Crystal River Nuclear Plant  
Docket No. 50-302  
Operating License No. DPR-72

**Subject:** Crystal River Unit 3 – Response to Request for Additional Information to Support NRC Balance of Plant Branch Acceptance Review of the CR-3 Extended Power Uprate LAR (TAC No. ME6527)

**RESPONSE TO REQUEST FOR ADDITIONAL INFORMATION  
TO SUPPORT NRC BALANCE OF PLANT BRANCH  
ACCEPTANCE REVIEW OF THE CR-3 EPU LAR**

**EFW PUMP RECIRCULATION VALVE SIMPLIFIED  
DIAGRAMS (FIGURES 1 AND 2)**

## Simplified Diagram of EFP-3 Recirculation Valve

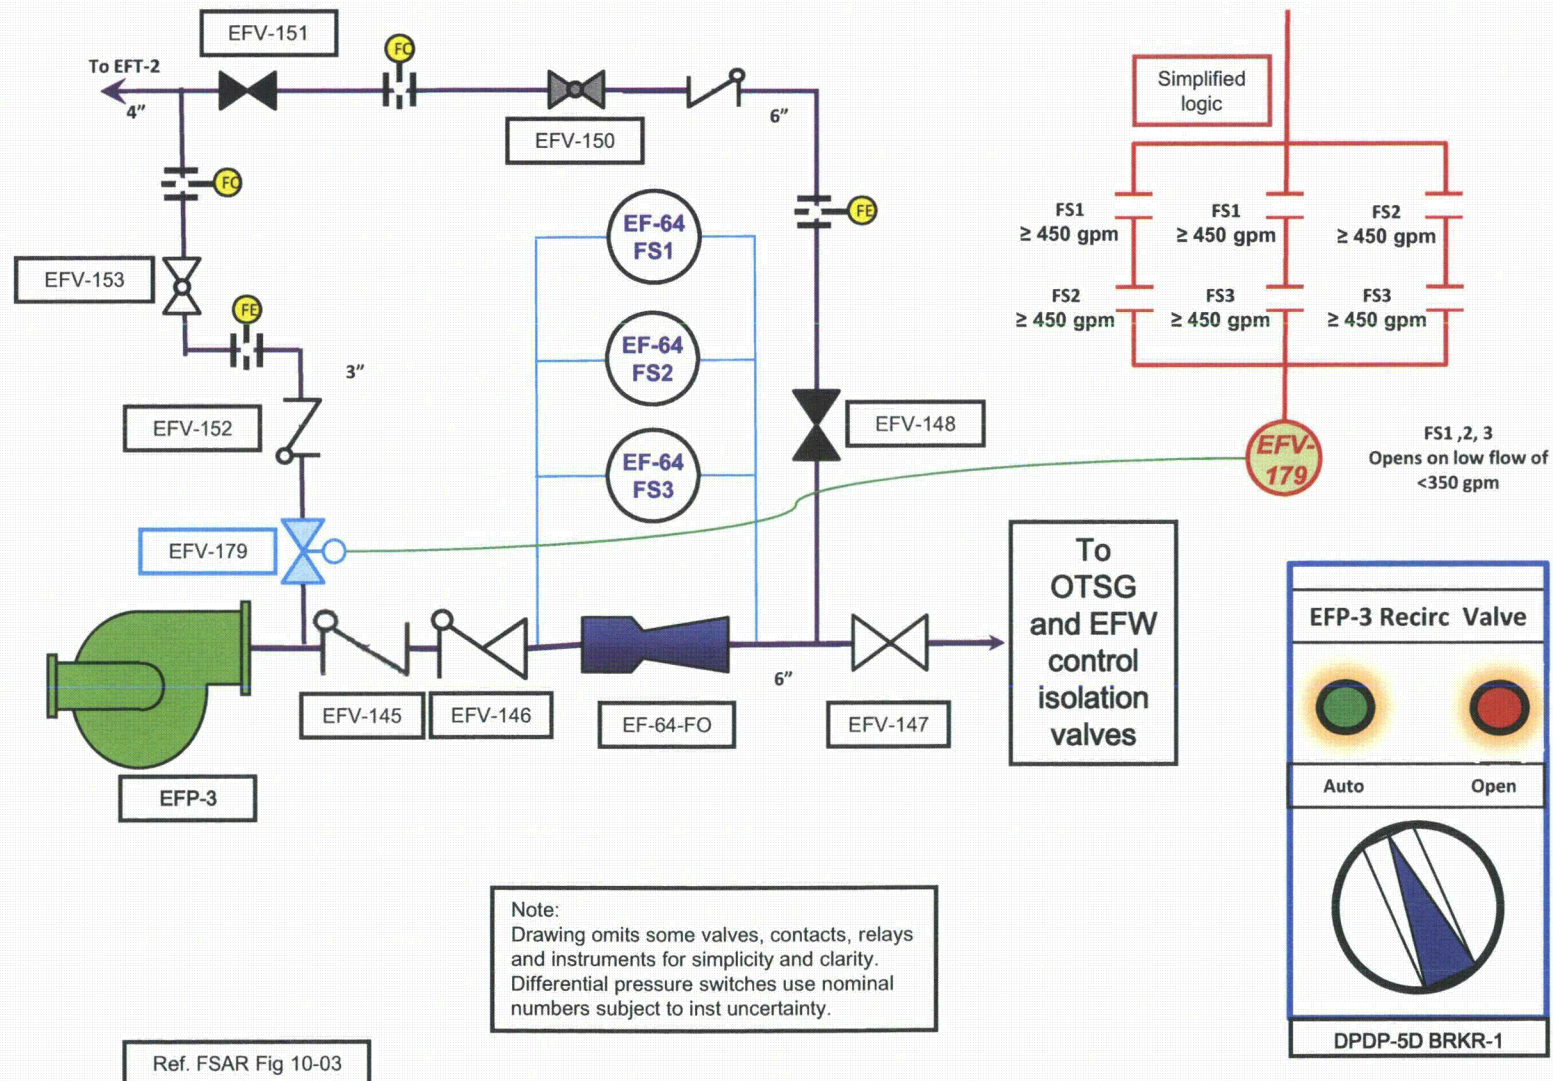
3. In several locations in the LAR, the licensee briefly describes a modification to the minimum flow recirculation control for the emergency feedwater pumps. Improper operation of the modification could cause failure of the pump, and the modification could be configured such that it introduces cross-train dependencies. The licensee must provide details of the modification necessary to establish that the modification would not adversely affect the independence of the emergency feedwater trains, such as a failure modes and effects analysis, and that the modification would not substantially reduce the reliability of the individual pumps (TMI Action Plan Item II.E.1.1), consistent with the guidelines of SRP Section 10.4.9.

The EFW System consists of two independent, 100% capacity, safety-related trains. The A EFW train consists of a diesel driven pump (EFP-3), flow limiting cavitating venturi, and flow control valves to each OTSG. The B EFW train consists of a turbine driven pump (EFP-2), flow limiting cavitating venturi, and flow control valves to each OTSG. Each of the new recirculation valves will be controlled by three safety-related differential pressure switches that sense flow across the associated cavitating venturi. A “2 out of 3 logic” will be required to open or close the associated safety-related EFW pump recirculation valve. EFW pump recirculation valve simplified piping diagrams are provided in Enclosure 3 showing the new valves in the EFW pump recirculation line and the sensing differential pressure instrumentation. The differential pressure switches, logic, control and motive power for each recirculation valve will be powered from the same safety-related electrical train as the associated EFW train.

A control switch will be added to the control room for each of the new EFW pump recirculation valves. Each switch will have “open” position to allow overriding the automatic operation forcing the valve to the open position. Control room alarms will also provide indication of the new valves “out of position” when the control switches are overriding the automatic function. As stated in the proposed CR-3 Improved Technical Specifications (ITS) Bases B 3.7.5, “Emergency Feedwater System” (Reference 1, Attachment 4), the EFW pump low flow instrumentation is required to be capable of closing the associated recirculation line isolation valve in sufficient time to ensure that EFW discharge flow to the OTSGs as assumed during transients and accidents is met. Thus, if an EFW pump recirculation valve control switch is placed in the open position, the associated EFW train would be rendered inoperable and ITS 3.7.5 Actions would apply.
